Contract #: 04-0120F4Cty: SF/ALA Rte: 80 PM: 13.2/13.9File #: 69.28**WELDING INSPECTION REPORT****Resident Engineer:** Pursell, Gary**Address:** 333 Burma Road**City:** Oakland, CA 94607**Report No:** WIR-001139**Date Inspected:** 20-Nov-2007**Project Name:** SAS Superstructure**OSM Arrival Time:** 630**Prime Contractor:** American Bridge/Fluor Enterprises, a JV**OSM Departure Time:** 1530**Contractor:** Zhenhua Port Machinery Company, Ltd (ZPMC), Changxing Island **Location:** Shanghai, China**CWI Name:** Sun Wei**CWI Present:** Yes No**Inspected CWI report:** Yes No N/A**Rod Oven in Use:** Yes No N/A**Electrode to specification:** Yes No N/A**Weld Procedures Followed:** Yes No N/A**Qualified Welders:** Yes No N/A**Verified Joint Fit-up:** Yes No N/A**Approved Drawings:** Yes No N/A**Approved WPS:** Yes No N/A**Delayed / Cancelled:** Yes No N/A**Bridge No:** 34-0006**Component:** Tower Mock-up and OBG**Summary of Items Observed:**

WELDING INSPECTION REPORT

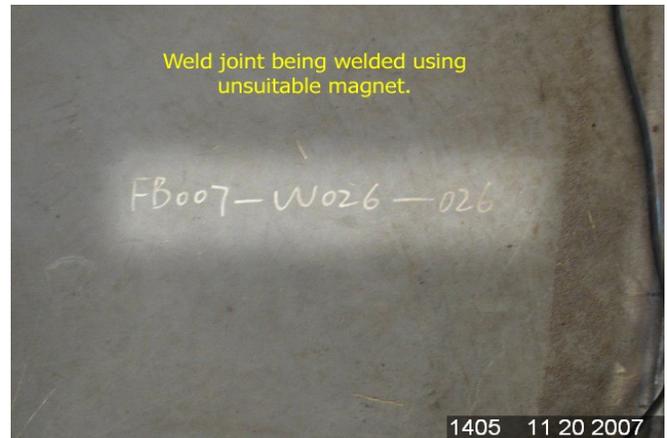
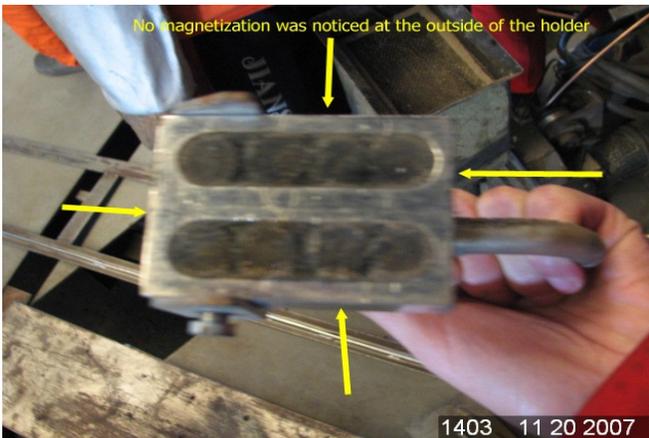
Item Description	WBS	Dwg No.	Status
1 Tower 89 Meters Mock-up Shear links Mechanical straightening			
<p>The QA inspector had a conversation with the ZPMC representative Li Xiu Yang. The QA inspector asked where and why 9 sections (3 webs and 6 flanges) from the shear links were moved outside of the shop before fitting-up the subassembling MUSB-MA25 and MA26. Mr. Li Xiu Yang said to the QA inspector that all the parts were taken to be mechanical straightened because they were distorted from the welding process. The QA inspector asked if ZPMC confirmed that the shear link were Seismic Performance Critical members (SPCM). Mr. Li Xiu Yang said that in previous conversation with the QA inspector, he informed to the QA inspector that ZPMC representative Mr. Hu Gang said to him that the Shear links were not SPMC material. The QA inspector had a conversation with ABF representative Mr. Kevin Carpenter. The QA inspector informed to Mr. Kevin Carpenter and Kevin Dye that ZPMC said to him that ZPMC performed mechanical straightening when the shear link material was SPMC member and section 12 prohibits cold bending. Mr. Kevin Carpenter informed that ABF would confirm that ZPMC did perform cold bending to the 3 webs and 6 flanges from the shear links subassembling MA-25 and MA-26. Later, ABF representative Kevin Dye relayed to the QA inspector that ZPMC straightened mechanically all the above parts mentioned and asked to the QA inspector if Caltrans was going to write a non conformance report regarding this issue. The QA inspector had a conversation with Caltrans Task Leader Robert Cuellar. The QA inspector brought to the attention that according with ZPMC and ABF 3 webs and 6 flanges components from the SPMC shear links were not fabricated as per section 12.12</p>

2 Welding SPCM floor beam splices with unsuitable magnet

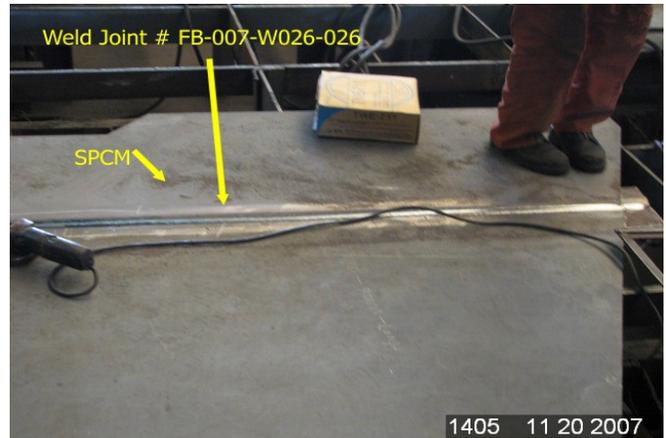
The QA inspector observed that welder Ms. Wu Zhibin was welding SPMC member for the floor beam splices 66A to 66B weld joint FB-007-W026-026 with a holder magnet inside the Hopper. The QA inspector verified the magnetization at the outside of the holder. The QA did not notice any relevant magnetization at the outside of the holder when the QA inspector located the magnetic holder against the steel. The QA inspector had a conversation with the ZPMC representative Shen Xue Jun. The QA brought to Mr. Shen Xue Jun that the magnet that ZPMC was using appeared not to be suitable to remove the unwanted particles before returning the flux to the system. Mr. Shen Xue Jun agreed and directed QC inspector and production supervisor to remove and change the magnetic holder. The photographs below show the magnetic holder and the SPCM floor beam being welded.

3 Tower Mock-up Welding Sequence

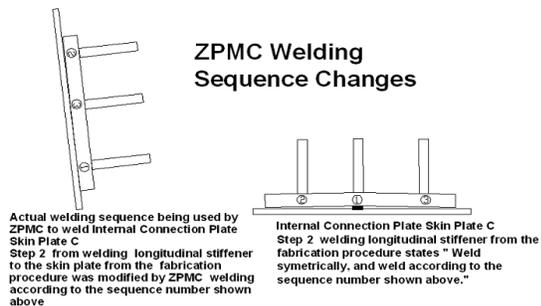
The QA inspector observed that ZPMC changed the welding sequence when welding longitudinal stiffeners to the skin plates. The QA inspector observed that fabrication procedure were not follow. The sketch below shows the changes in the welding sequence on ZPMC fabrication procedures for the interior connection plate for the Skin C from Tower Mock-up 114 Meters to improved the welding quality. Changes were observed also on the welding sequence on Skin plate A from Tower Mock-up 89 M.
